## **COLE'S PLACE SUBDIVISION, UNIT THREE**

APPLICATION NUMBER 3 DATE May 20, 2010

REQUEST Subdivision

# DETAIL SITE PLAN

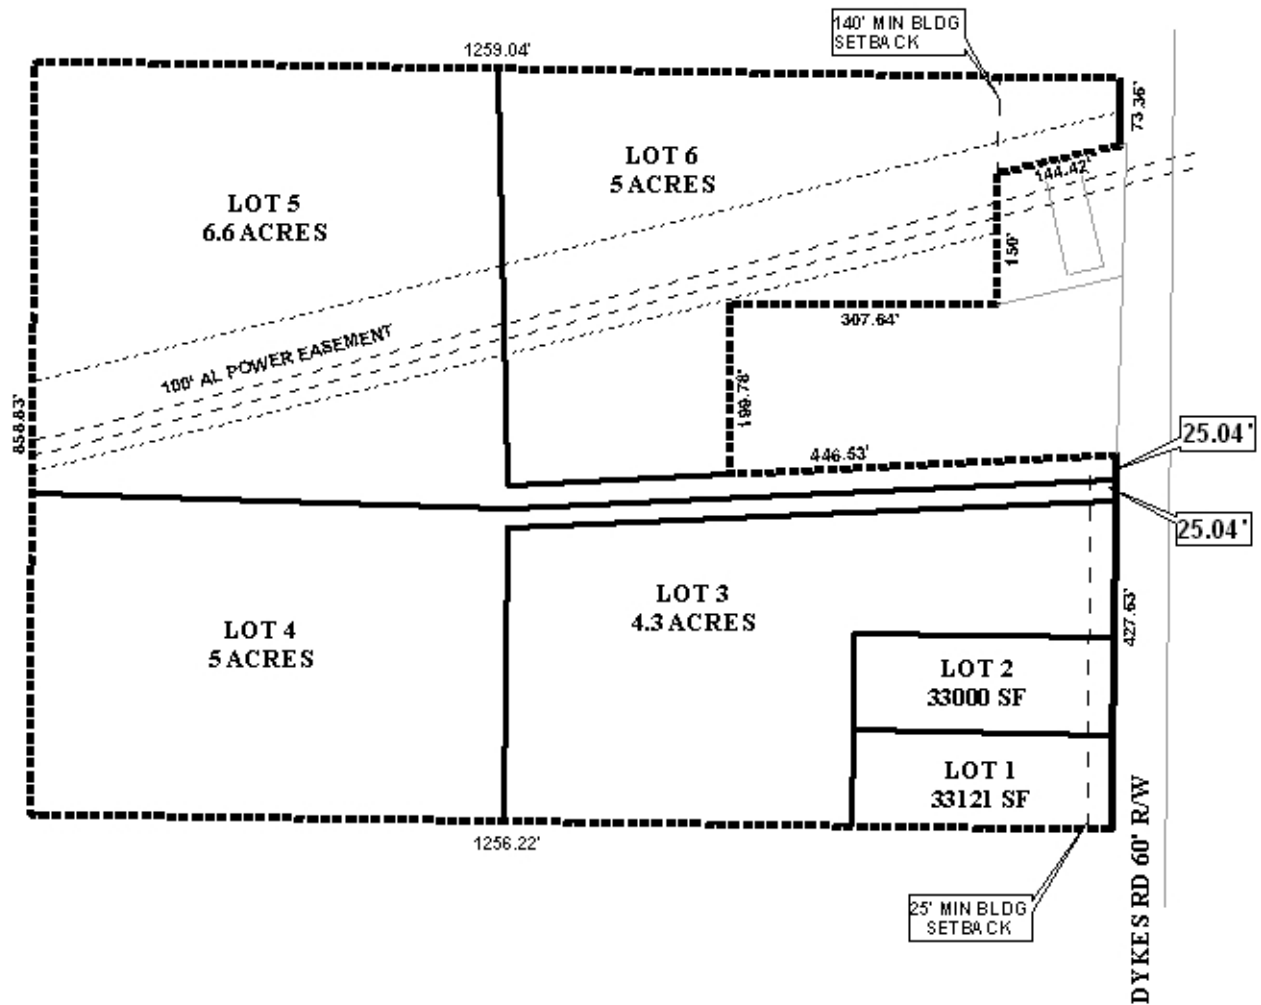
Four of the proposed six lots will be flag-lots. As proposed, Lots 3, 4, 5 and 6 exceed the maximum width to depth ratio; therefore, a waiver of Section V.D.3. of the Subdivision Regulations would be required. The Subdivision Regulations state that the maximum depth of a lot should not exceed 3.5 times the width of the lot. While this Section (V.D.3.) is often waived by the Commission, the lots are typically along waterways, or the proposed lots would be characteristic of the surrounding development. In this situation, there is an almost identical flag-lot subdivision approved in 2008 located across the street, making the proposed plat in character with the area. Furthermore, a 100-foot wide Alabama Power easement crosses the property, constraining how the property can be developed; thus, a note should be placed on the Final Plat stating that no construction will be allowed within this easement.

Due to the limited width of several of the proposed lots, access management is a concern. Proposed lots 1, 2, 3 and 6 should be limited to one curb-cut each, while proposed lots 4 and 5 should be limited to one shared curb-cut, with the size, design and location of all curb-cuts to be approved by Mobile County Engineering and comply with AASHTO standards.

The 25-foot minimum building setback line is not depicted on all lots, and should be revised on the Final Plat to depict the 25' setback line on all lots and on the flag lots where the pole meets the flag, if approved.

The site is located in the county. Therefore, a note should be placed on the final plat stating that any lots developed commercially and adjoin residentially developed property must provide a buffer, in compliance with Section V.A.8 of the Subdivision Regulations.

- 1) no construction allowed in the 100' Alabama Power easement;
- 2) depiction of the 25-foot minimum building setback line on all lots and on the flag lots where the pole meets the flag;

- 3) placement of a note on the Final Plat stating that lots 1, 2, 3 and 6 are limited to one curb-cut each, while proposed lots 4 and 5 are limited to one shared curb-cut, with the size, design and location of all curb-cuts to be approved by Mobile County Engineering and comply with AASHTO standards;

- 4) retention of the labeling of the size of the lot, in square feet, or provision of a table on the plat with the same information;
- 5) Must comply with Engineering comments: *Must comply with the Mobile County Flood Damage Prevention Ordinance. Development shall be designed to comply with the storm water detention and drainage facility requirements of the City of Mobile storm water and flood control ordinances, and requiring submission of certification from a licensed engineer certifying that the design complies with the storm water detention and drainage facility requirements of the City of Mobile storm water and flood control ordinances prior to the issuance of any permits. Certification is to be submitted to the Planning Section of Urban Development and County Engineering;*

- 6) placement of a note on the Final Plat stating that no future resubdivision until adequate frontage on a County maintained public right-of-way is provided;

- 7) revision of the note on the Final Plat stating that any lots which are developed commercially and adjoin residentially developed property must provide a buffer, in compliance with Section V.A.8 of the Subdivision Regulations;

- 8) revision of the note on the Final Plat stating that approval of all applicable Federal, state and local agencies for endangered, threatened or otherwise protected species is required prior to the issuance of any permits or land disturbance activities; and
